# PLANNING BOARD REPORT PORTLAND, MAINE

Bank/Office Building with Bank Drive-through, 20 Marginal Way  
Level III Conditional Use and (Level II) Site Plan  
Bangor Savings Bank, Applicant  
Project #: 2015-080  
CBL 113 A025001

Submitted to: Portland Planning Board Public Hearing Date: July 14 <sup>th</sup> , 2015	Prepared by: Jean Fraser, Planner Date: July 10 <sup>th</sup> , 2015
--	---

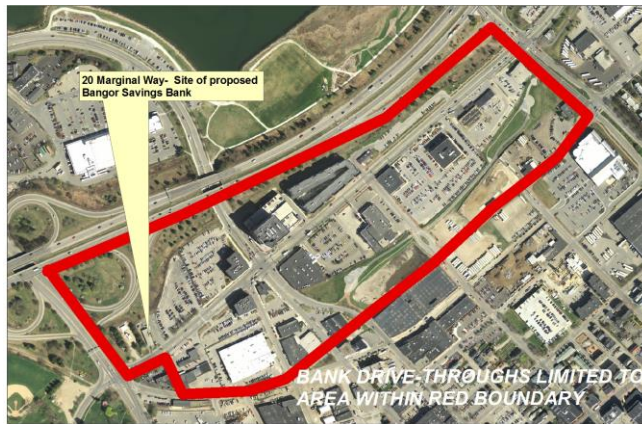
**Staff comment:** The proposed vehicle circulation takes the drive-through customers around the rearmost drive and then down the west side to enter the drive-through from the west. This provides stacking area along the west boundary of the site and ensures that it is not near Marginal Way nor across any pedestrian routes.

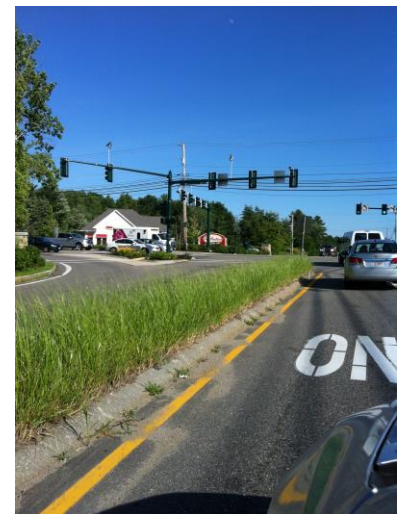
The site has limited areas for landscaping and the applicant had originally requested a waiver for parking lot landscaping (with contribution to the Tree Fund instead. Staff do not support the waiver because screening of parking is also part of the B7 Design Standards, and because of the absence of landscaping along the eastern boundary (where the view towards the proposed parking is clearest from the sidewalk and street).

Staff met with the applicant and suggested that there was scope for a number of smaller spaces for planting so that cumulatively the landscape would meet the ordinance requirements which state:

The final Landscape Plan (Plan P10) has been prepared by a Landscape Architect and includes many improvements, although the City Arborist remains of the view that more could be done (Attachment 3):

*The proposed Bangor Savings Bank landscape plan for Marginal Way is acceptable with the condition that ONE tree is planted in the rear right side traffic island and vegetation is added to the proposed rear curbing area.*

- iv. That the applicant shall submit a revised Landscape Plan, for review and approval by the City Arborist and the Planning Authority prior to the issuance of a building permit, that adds one tree to be planted in the rear right side traffic island and adds vegetation to the proposed rear curbing area to address the City Arborist comments dated 7.2.2015; and
